BEFORE THE DUNEDIN CITY COUNCIL

Land Use Consent Application to
construct and operate a commercial
residential development by NZ
Horizons Hospitality Group Limited.

STATEMENT OF EVIDENCE OF GRAEME ROBERT McINDOE
Urban Design
24 July 2017

Figure 2: View up Harrop Street

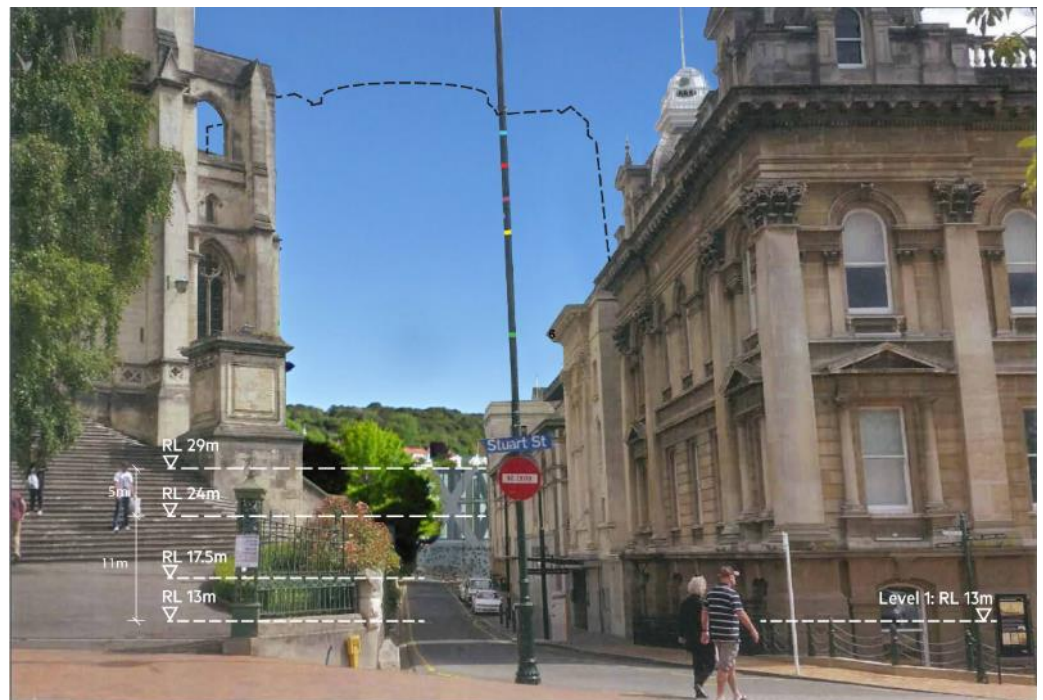
- 70 Figure 2 is derived from the Paterson Pitts view No 5 along Harrop Street. It refers to the known and proposed levels, and is produced using Photoshop:

- 71 Figure 2 demonstrates:
- (a) the less than minor effects of a podium that is around 11.5m high directly across Moray Place;
 - (b) the absence of visual impact on the Town Hall, Cathedral and views from the Octagon with a building of this height;

- 75 However I can comment on one assessment and that is where Mr Compton-Moen's view from the Octagon (VSR13) correlates with Paterson Pitts' view No. 5. Mr Compton Moen identifies correctly that views of the town belt will be blocked by the proposed building, but also considers it *"likely these would have been blocked by an 11m high building in any case"*¹³. That is incorrect as can be seen in Figure 2.

- 76 Mr Compton-Moen's evidence confirms his opinion that the impact on views from the Octagon is 'less than minor'. That is also in my opinion incorrect as demonstrated by Figure 2, and with reference to the criteria Mr Compton-Moen has suggested and that I have also used. As the impact is significant, and it can't be mitigated, it is correctly categorised as 'unacceptable'.

Figure 3: Arrows identifying where additional view simulations are required to describe effects of the Proposal on views of the Cathedral and Town Hall, and from the Octagon.

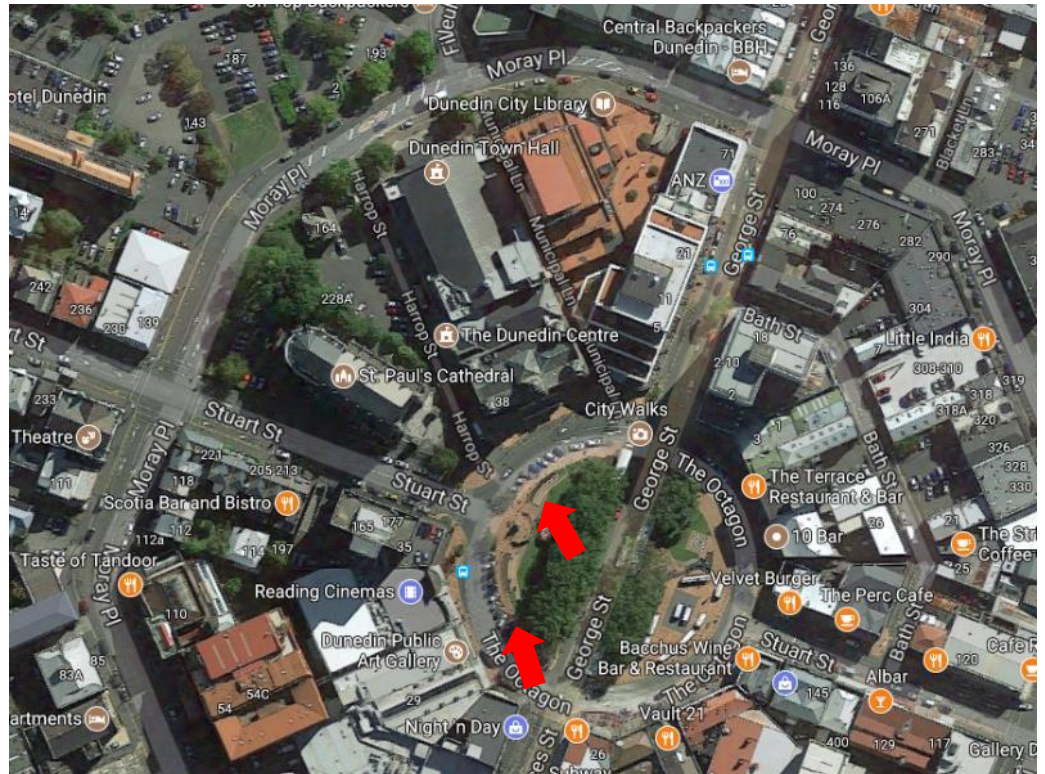
- 79 Two such points are identified in identified in Figure 3 below, being on the footpath at the north-western corner of the Octagon and Princes Street, and from the centre of the Octagon, in any location between the two pedestrian canopies there.

- 80 Positioned behind St Pauls Cathedral and the Town Hall, the anticipated effect of the Proposal on views from the identified points of entry to and at the centre of the Octagon but on the Town Hall side of the trees is likely to be significant, and unable to be mitigated – that is, unacceptable.¹⁵
- 81 The Proposal will appear behind and above these heritage buildings and can be expected to dominate views of them. The landmark Town Hall clock tower and Cathedral (spires) are prominent on the skyline, and these are likely to be subsumed into the Proposal, compromising their visual singularity and prominence.

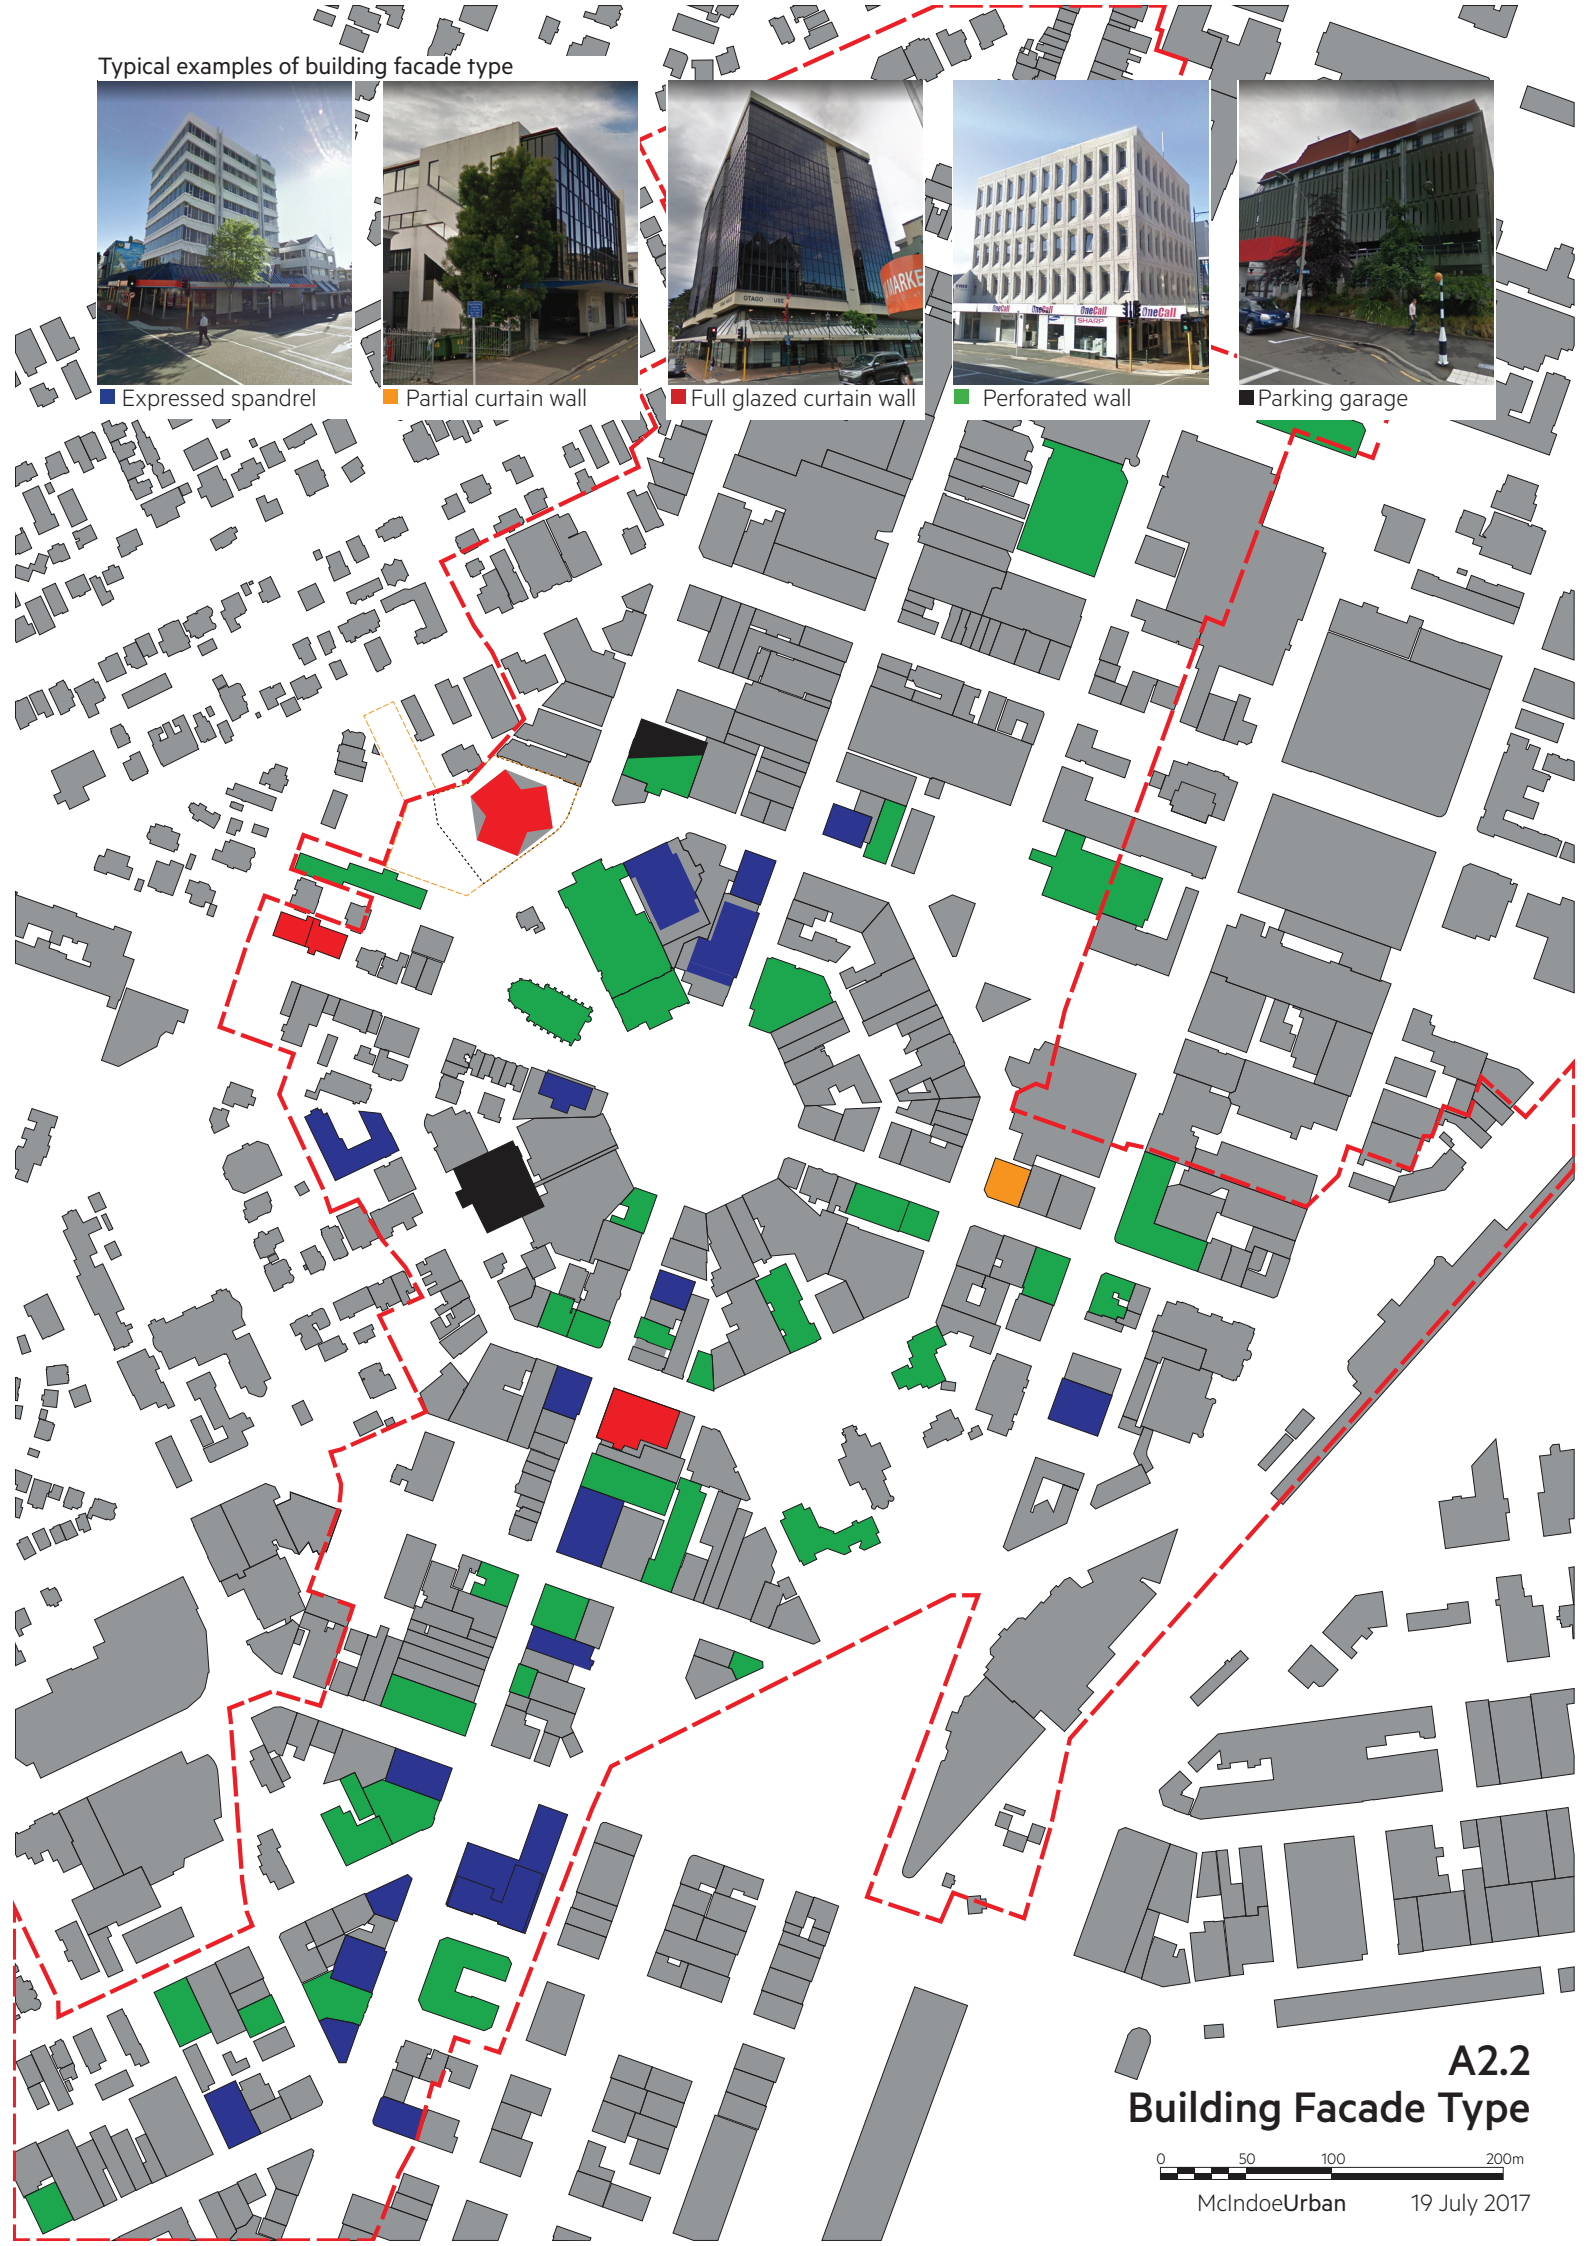
- 34 Drawing A2.2 categorises the types of façade for those buildings that are 4 or more storeys high¹. The categorisation relates to façade type not style. For example the perforated wall 'type' includes both a modern building and the Victorian and Edwardian buildings that are common in Dunedin. The Proposal is for a "lightly tinted green glass curtain wall".

- 35 Considering the 55 buildings identified as being of four or more storeys, this demonstrates that the majority of these buildings are of a 'perforated wall' or 'expressed spandrel' type.

A2.3 Building Facade Alignments

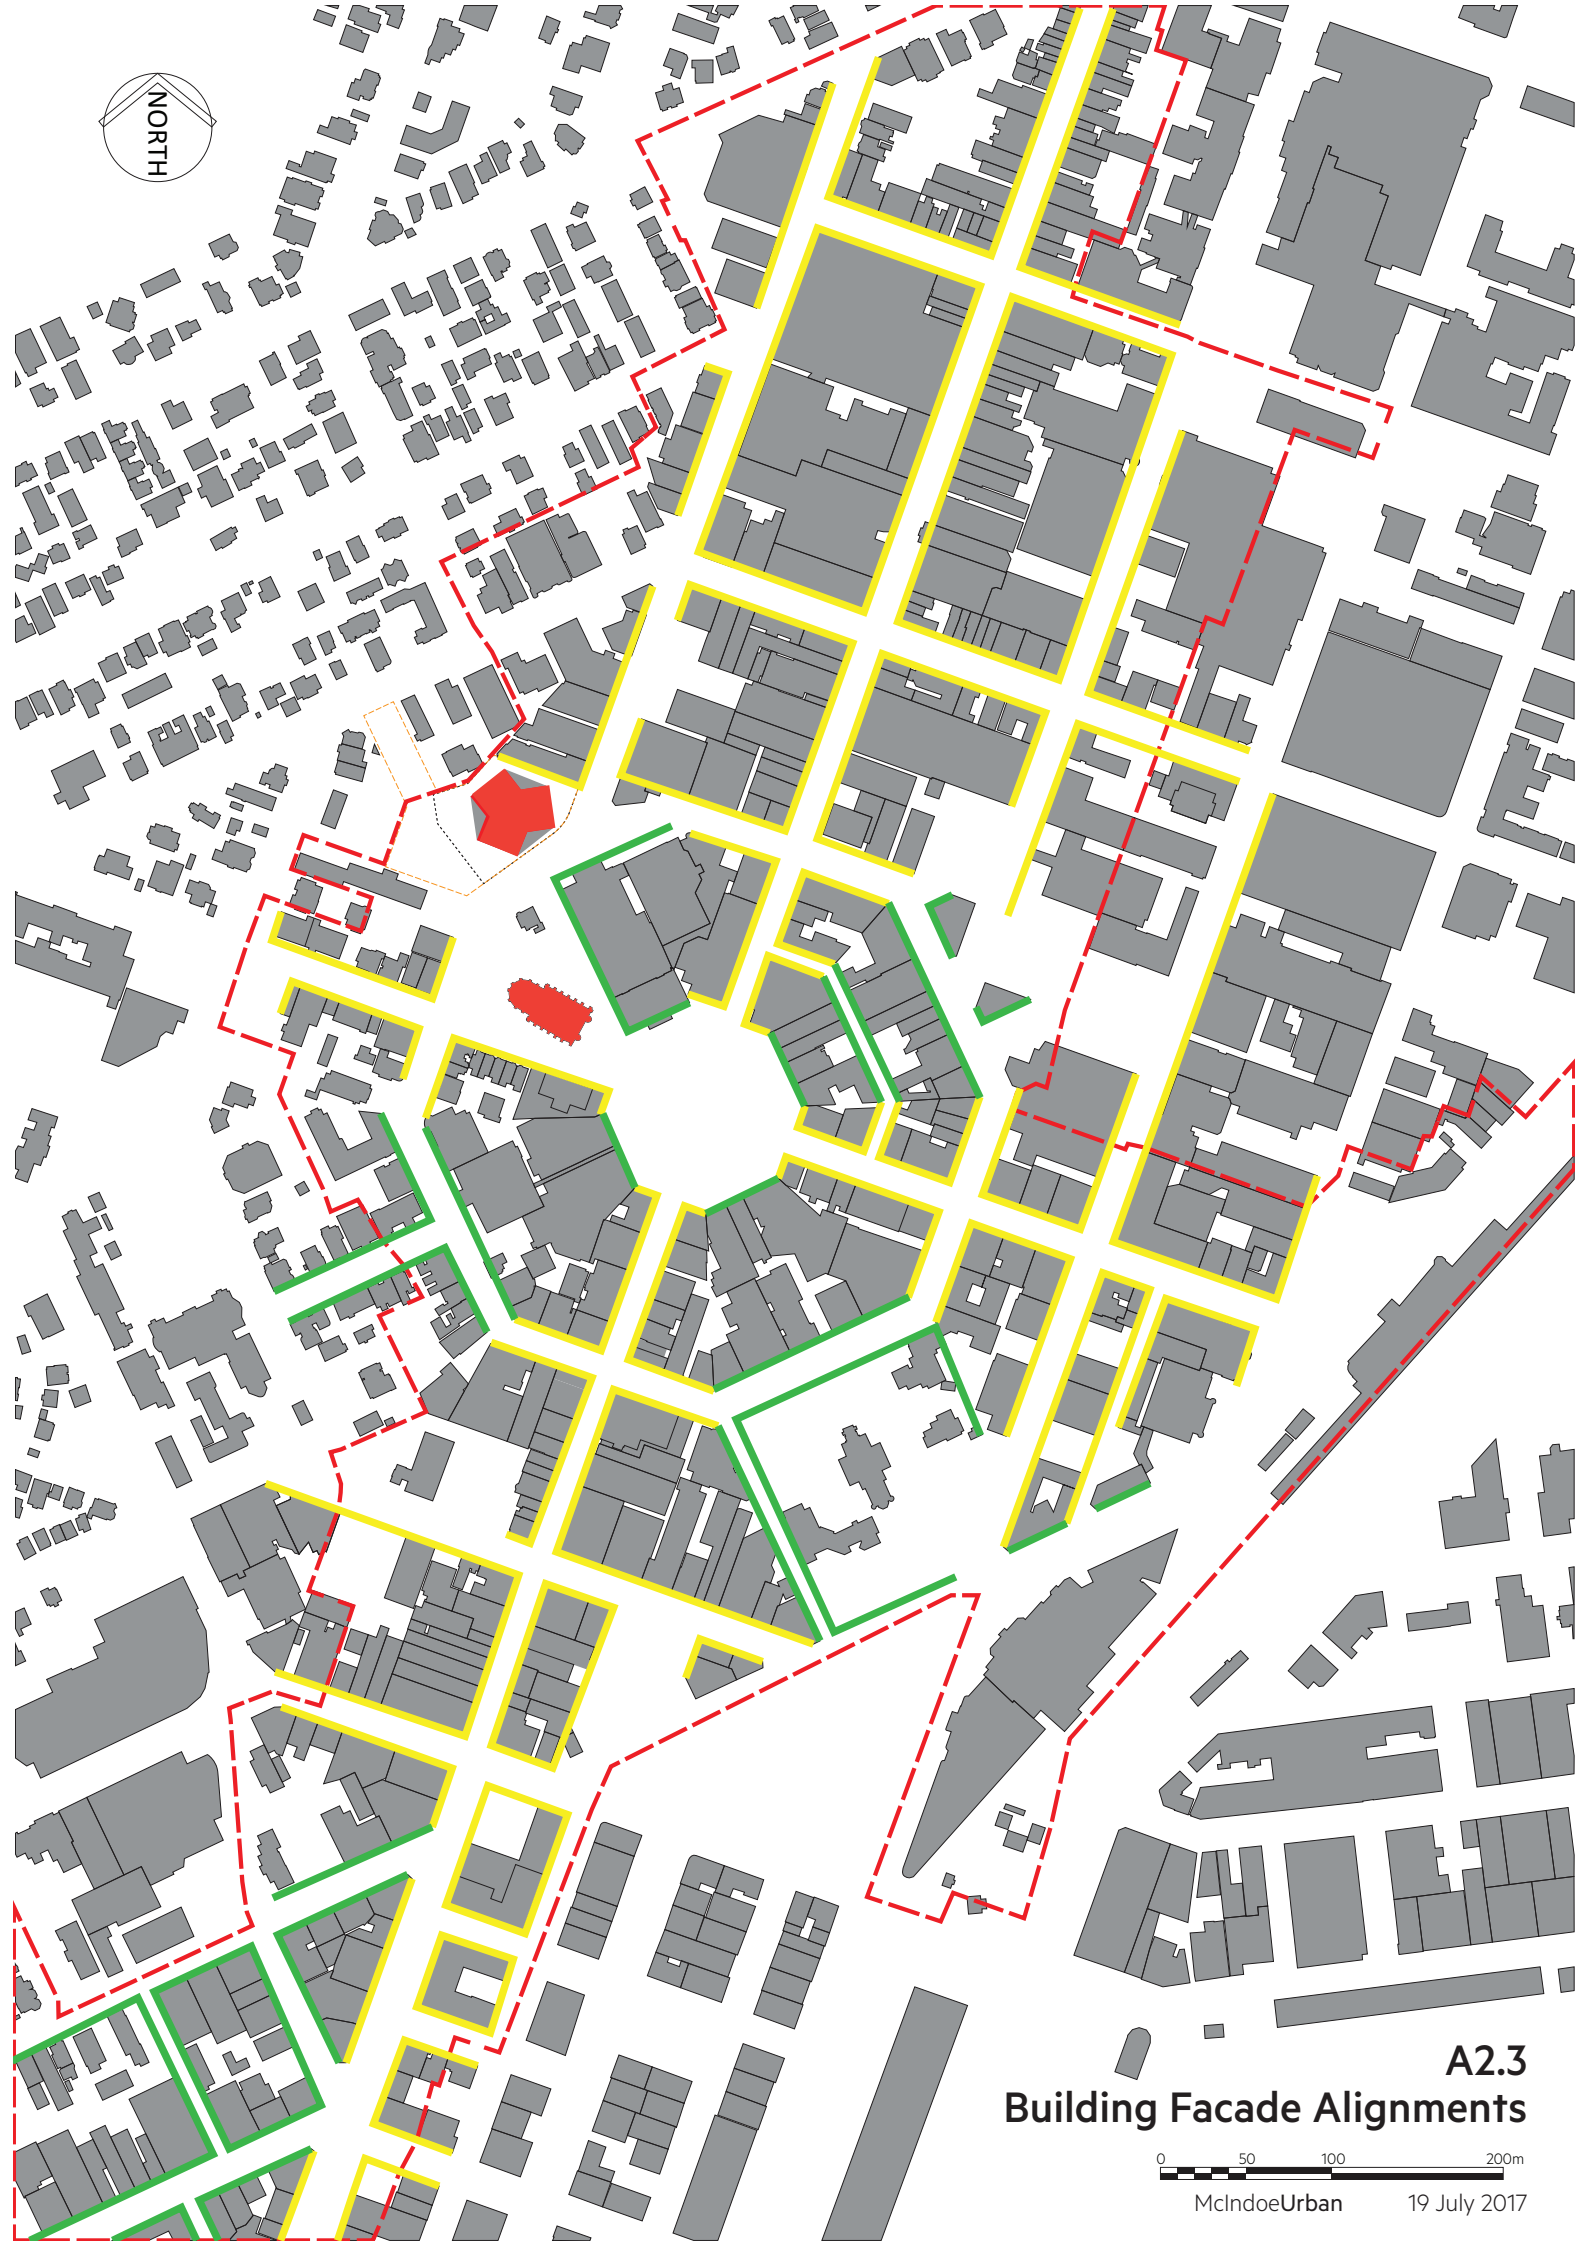
- 37 Drawing A2.3 identifies the common alignments of building façades. This demonstrates:
- (a) The city centre shows a remarkable degree of consistency in alignments being based on the north-south/east-west grid defined by George/Princes Street and Stuart Street (diagrammed in yellow), and the diagonal grid seen with High Street and around the Octagon (diagrammed in red).
 - (b) Only one existing building departs from alignment with these two grids. This is St Paul's Anglican Cathedral which is identified in red. The Proposal's tower, also identified in red, would be the second departure.
- 38 The proposed podium relates to the Moray Street edge. However, the tower, being the largest, tallest and most visually significant part of

- 39 The proposal has a singular plan form and alignment, and the only other building within this area that takes a similar approach is St Paul's Cathedral. That building has an important religious and cultural function, and singularity of form and design within any centre has historically been a desirable characteristic of such buildings.
- 40 The alignment of the tower has two effects being that it:
 - (a) Is inconsistent with the established and overwhelmingly consistent patterns of building alignment in the city centre; and
 - (b) Detracts from the status of the Cathedral as a singular building with a unique plan alignment.
